Storage and Disposition of Weapons-Usable Fissile Materials Final PEIS

NEUSCH, TRISH, PANHANDLE, TX
PAGE 1 OF 3

Figure 2.4–4. Conceptual Facility Location for the Disposition of Plutonium at Pantex Plant.

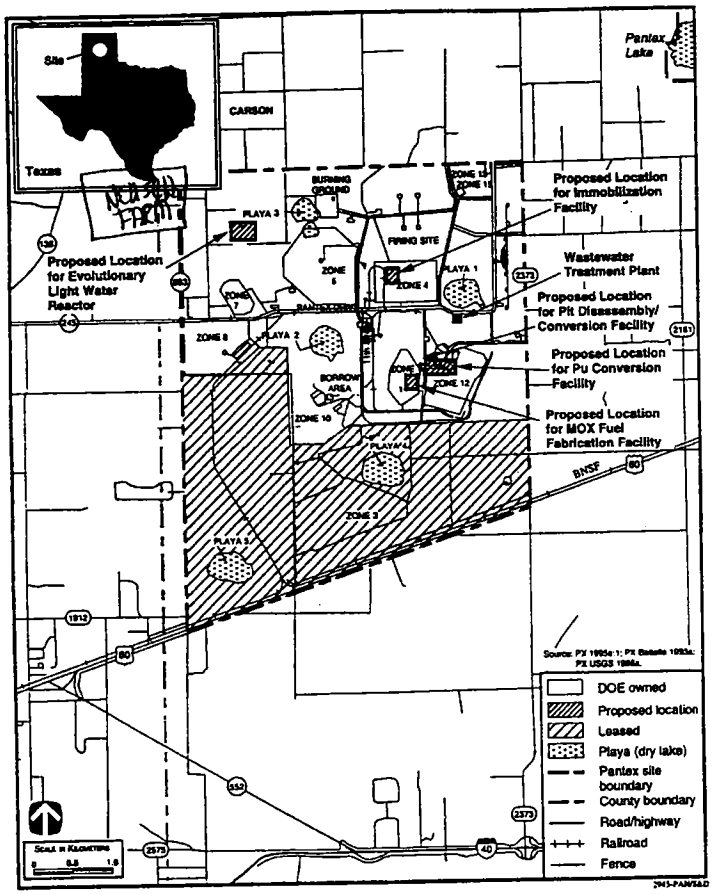
I became very concerned recently while reading the Storage & Disposition of Weapons-Usable Fissile Materials Draft PEIS (S+D-PEIS). If you will notice on page 2-80 of this document a map displaying the conceptual facility location for the disposition of plutonium at Pantex. If you will look in the northwest corner of the Pantex Plant site there is a proposed site for an Evolutionary Light Water Reactor (LWR). I don't know what anyone else thinks, but I think it's a crying shame that any of these options are even being considered, much less actually built in the future, in this rich agricultural productive area. There are several of you who feel agriculture is not that important or beneficial to this area. I want you to think about that when you sit down to dinner tonight. 1/08.03.01

The Department of Energy acknowledges the commentor's opposition to new missions at Pantex. Decisions on storage and disposition of weapons-usable fissile materials will be based upon environmental analyses, technical and economic studies, national policy considerations, and public input.
